Proposal for Supplement 6 to UN Regulation No. 108 (Retreaded tyres for passenger cars and their trailers)

Submitted by the Working Party on Noise and Tyres*

The text reproduced below was adopted by the Working Party on Noise and Tyres (GRBP) at its seventy-fourth session (ECE/TRANS/WP.29/GRBP/72, para. 17). It is based on ECE/TRANS/WP.29/GRBP/2021/15 as amended by Annex III to the report. It is submitted to the World Forum for Harmonization of Vehicle Regulations (WP.29) and to the Administrative Committee (AC.1) for consideration at their March 2022 sessions.

"1. Example of the markings to be borne by retreaded tyres placed on the market after the entry into force of this Regulation

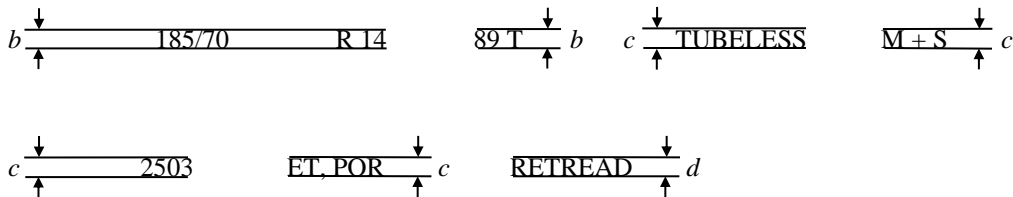
Paragraph 1., amend to read:

of special-use professional off-road (POR) or extra tread (ET) type."

b : 6 mm (min.)
 c : 4 mm (min.)
 d : 3 mm (min.)
 and from 1998, 4 mm (min.)

These markings define a retreaded tyre:

having a nominal section width of 185;

having a nominal aspect ratio of 70;

of radial-ply structure (R);

having a nominal rim diameter of code 14;

having a service description "89T" indicating a load capacity of 580 kg corresponding to a load index of "89" and a maximum speed capability of 190 km/h corresponding to a speed symbol "T";

for fitting without an inner tube ("TUBELESS");

of snow type (M+S);

retreaded in the weeks 25, 26, 27 or 28 of the year 2003;
